Access Compliance Report

Public Rights-of-Way

(Pedestrian Signals)

Intersection ID: N/A	Main Street:	Cross Street: N/A	Location: N/A
ADA ID: B164C921AC76	Signal Type: Two Push Buttons-Non APS	Overall Compliance: No	Severity Score: BTN 1:N/A BTN 2: N/A No BTN: N/A
Codes/Mitigation Info/Possible Solution		Field Measurements/Component Compliance

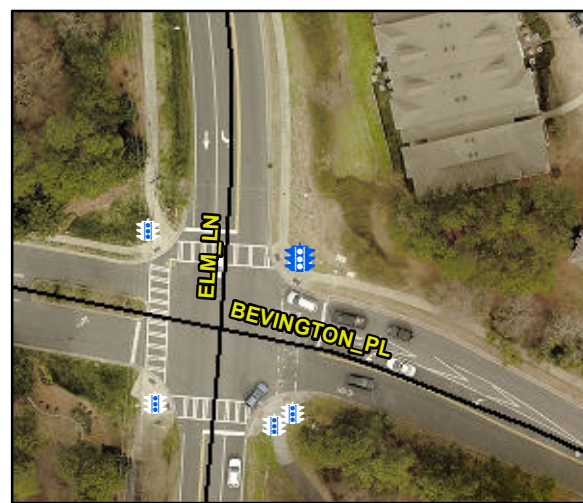
PROW/ADA: TMUTCD 4e.08, R404.2, R406.2, R404.3

Compliance	Description	Data	Compliance	Description	Data
	Button Count	Button2	N/A	Distant to Additional Button (in)	N/A
	Additional Button Present?	No		Additional Button ID	N/A
N/A	Signal Buttons Required?	N/A	N/A	Additional Ped Posts Required	N/A
	How Many Ped Street Xings?	2		Located In An Island/Median?	No
N/A	B 1 Sign Present?	Yes	N/A	B 2 Sign Present?	Yes
Yes	B 1 Sign Purpose?	Yes	Yes	B 2 Sign Purpose?	Yes
Yes	B 1 Sign Lettering & Contrast?	Yes	Yes	B 2 Sign Lettering & Contrast?	Yes
Yes	B 1 Parallel To XWalk?	Yes	Yes	B 2 Parallel To XWalk?	Yes
Yes	B 1 PAR to Button?	Yes	Yes	B 2 PAR to Button?	Yes
Yes	B 1 PAR to XWalk?	Yes	Yes	B 2 PAR to XWalk?	Yes
Yes	B 1 Clear Floor Space?	Yes	Yes	B 2 Clear Floor Space?	Yes
N/A	B 1 FWD Approach?	Yes	N/A	B 2 FWD Approach?	Yes
N/A	B 1 FWD Approach Constrained?	No	N/A	B 2 FWD Approach Constrained?	No
No	B 1 FWD Approach Reach (in)	7.0	No	B 2 FWD Approach Reach (in)	8.0

N/A	B 1 FWD Approach Width (in)	N/A	N/A	B 2 FWD Approach Width (in)	N/A
N/A	B 1 FWD Approach Obstruction?	Yes	N/A	B 2 FWD Approach Obstruction?	Yes
N/A	B 1 FWD Approach Obstruction Dist (in)	0.0	N/A	B 2 FWD Approach ObstructionDist (in)	1.0
N/A	B 1 PARA Approach?	Yes	N/A	B 2 PARA Approach?	Yes
N/A	B 1 PARA Approach Constrained?	No	N/A	B 2 PARA Approach Constrained?	No
Yes	B 1 PARA Approach Reach (in)	5.0	Yes	B 2 PARA Approach Reach (in)	5.0
N/A	B 1 PARA Approach Width (in)	N/A	N/A	B 2 PARA Approach Width (in)	N/A
N/A	B 1 PARA Approach Obstruction?	Yes	N/A	B 2 PARA Approach Obstruction?	Yes
N/A	B 1 PARA Approach Obstruction Dist (in)	0.0	N/A	B 2 PARA Approach ObstructionDist (in)	0.0
Yes	B 1 Clear Floor Space Slope (%)	4.2	No	B 2 Clear Floor Space Slope (%)	4.2
No	B 1 Clear Floor Space XSlope (%)	2.4	No	B 2 Clear Floor Space XSlope (%)	2.3
N/A	B 1 PAR Slope (%)	4.3	N/A	B 2 PAR Slope (%)	2.0
Yes	B 1 Height (in)	40.0	Yes	B 2 Height (in)	40.0

Yes	B 1 Clear Xing Direction?	ClearlyMarked	Yes	B 2 Clear Xing Direction?	ClearlyMarked
	B 1 Crossing Direction	To W		B 2 Crossing Direction	To S
Yes	B 1 DistanceTo XWalk (in)	0.0	Yes	B 2 DistanceTo XWalk (in)	0.0
No	B 1 DistanceTo Curb (in)	126.0	No	B 2 DistanceTo Curb (in)	128.0
Yes	B 1 Diameter (in)	2.0	Yes	B 2 Diameter (in)	2.0

Possible Solutions: Replace Signal Push Button With APS Button on New Post. Remove & Relocate Sign.
